<b>Arboricultural Advice</b>		<b>Prepared by:</b>	<b>Hal Appleyard</b>
<b>Project:</b>	<b>2 Maresfield Gardens, London NW3</b>	<b>Produced for:</b>	<b>AZ Urban Studio</b>
<b>Date: 13.06.16</b>	<b>Ref: ha/an1/2maresfield</b>		
<b>Planning Ref:</b>	<b>2015/6894/P</b>

## 1.0 Introduction

Negligible rooting within the heavy clay	The robust inspection chamber is arrowed and prevents lateral root growth

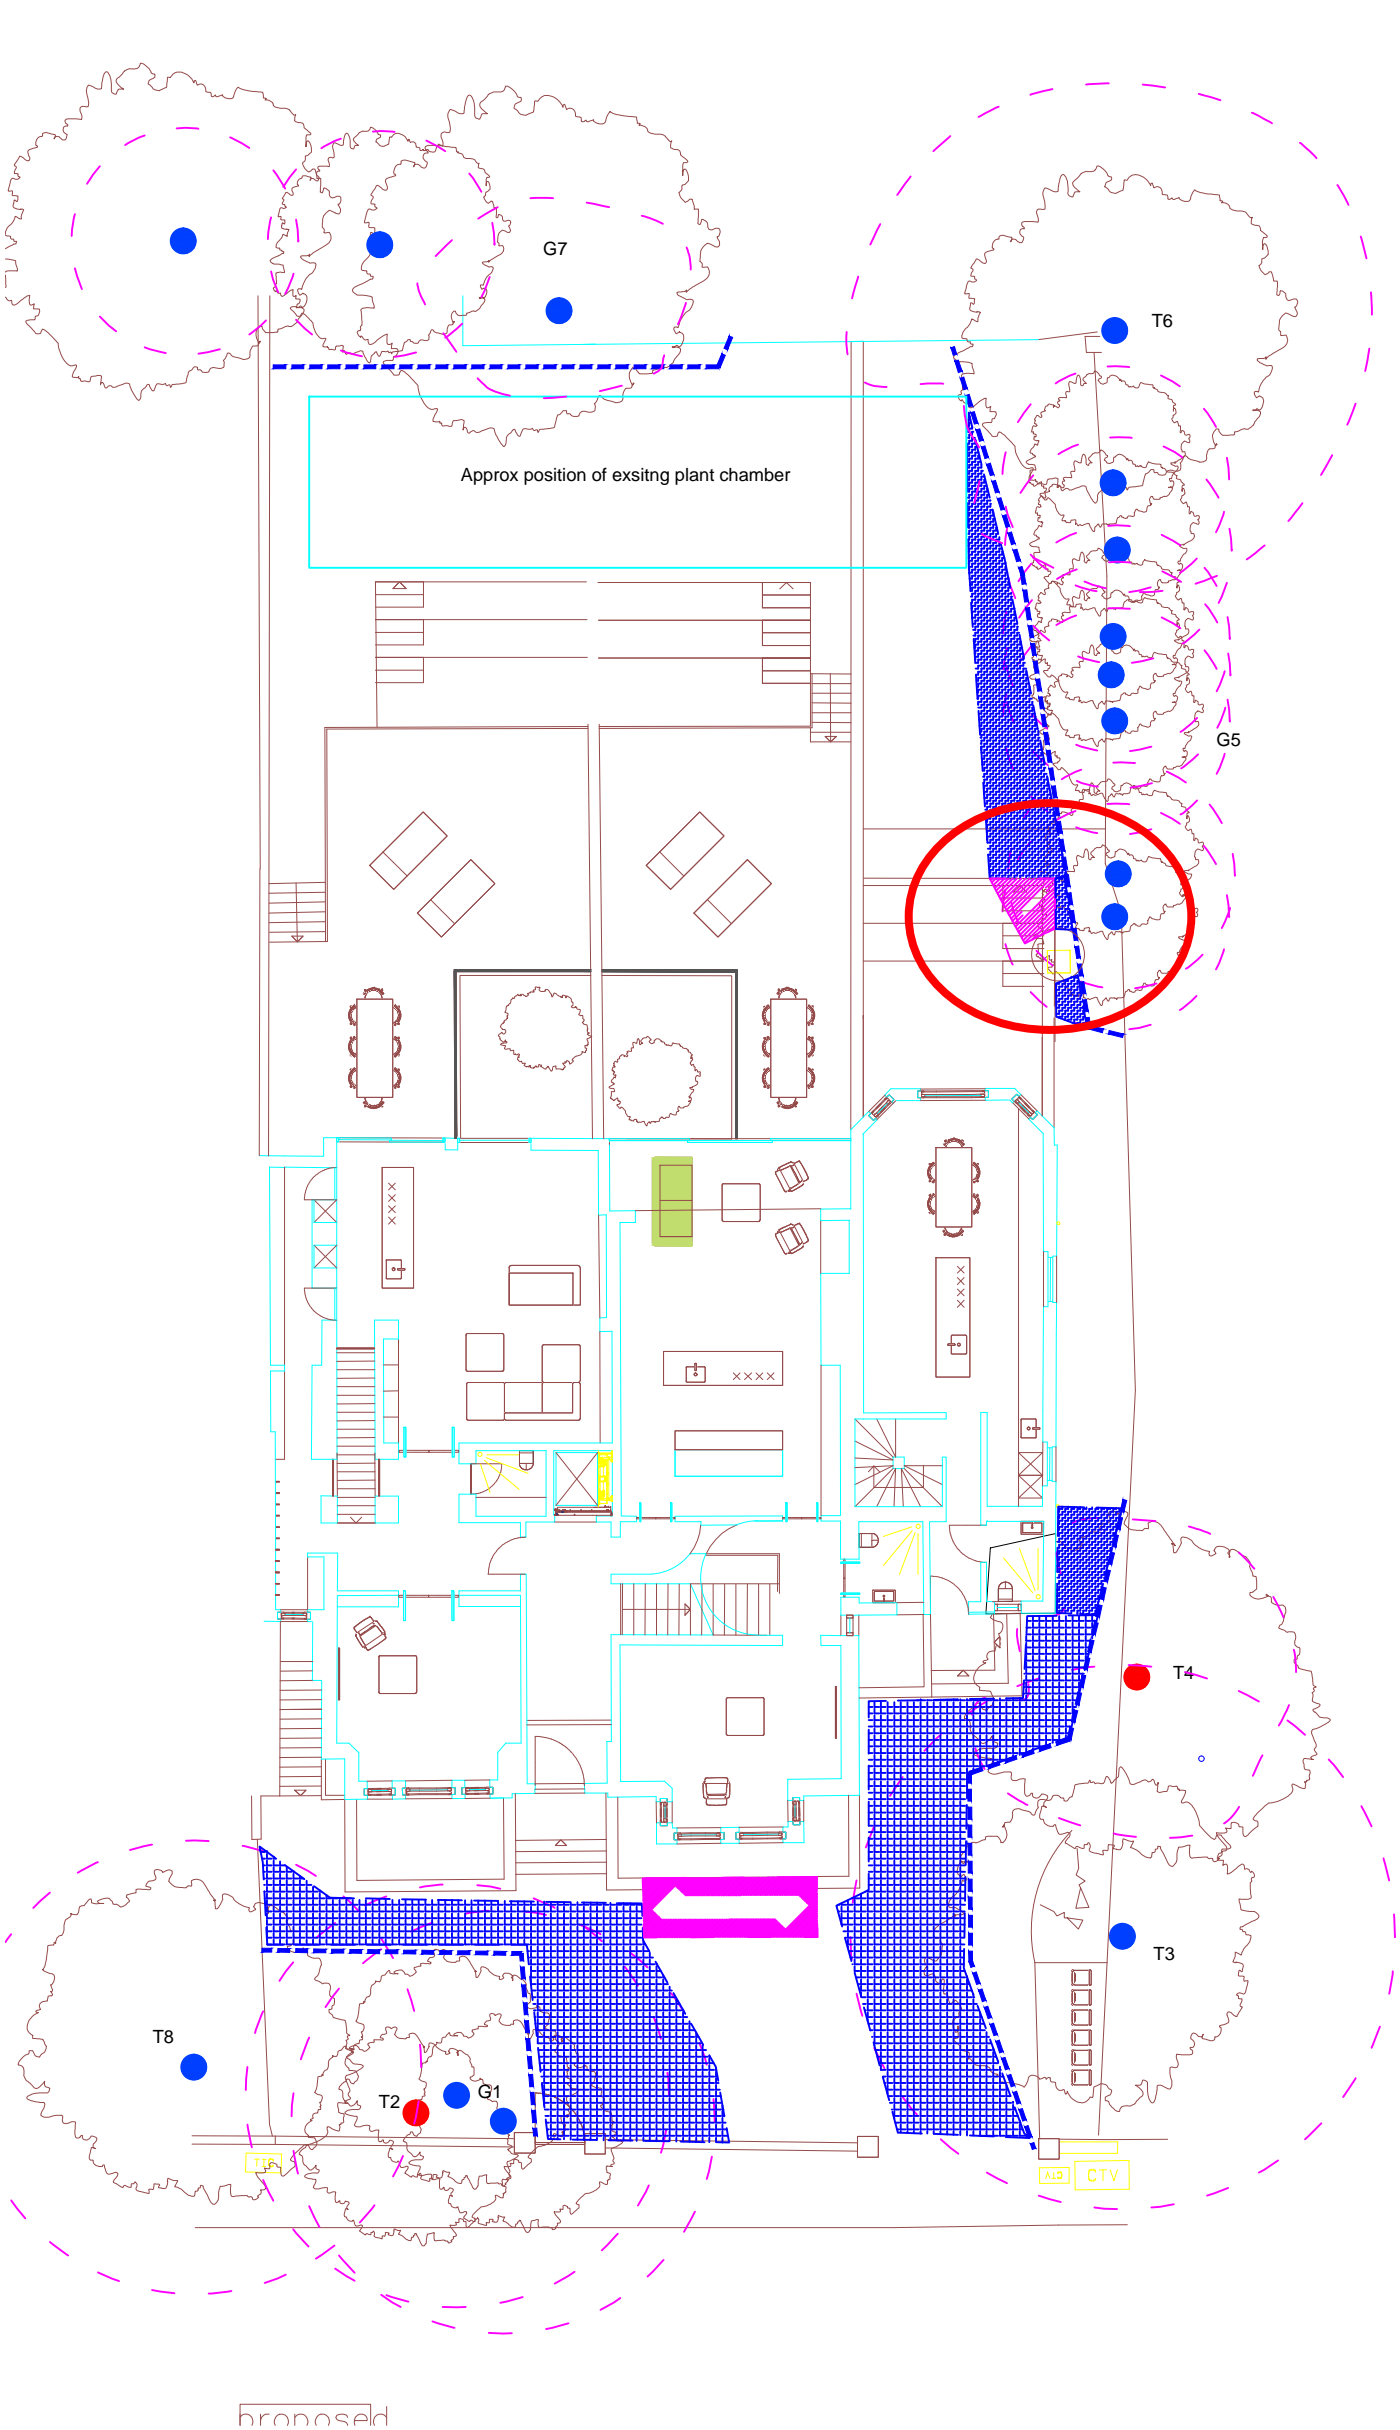
*'We [Ruskins] excavated a small pit around 90cm deep and 1 metre square, through thick heavy clay (the Air Spade was very very slow and we carefully hand dug where it was not working). **We found no roots.** The pit was much smaller than anticipated due to the adjacent and very large manhole cover. The extent of works in light of the manhole cover were agreed on site.'*

- 2.2 It is to be noted that the adjacent manhole (inspection chamber) is a mass concrete chamber, physically preventing lateral root growth. It is also to be noted that no roots were encountered, potentially owing to the very dense clay that was excavated, which is commonly an inhospitable growing medium. I have provided the photographic record below.

- 2.3 In view of the very heavy clay conditions, the lack of substantial rooting and the presence of existing physical root barriers to lateral growth, the prospect of harm arising to the retained trees within G5 is very low. This is not to say however, care is to be taken when excavating in this area for the construction of the proposed steps and it will continue to be prudent to undertake this work manually in the first instance, with specialist supervision.
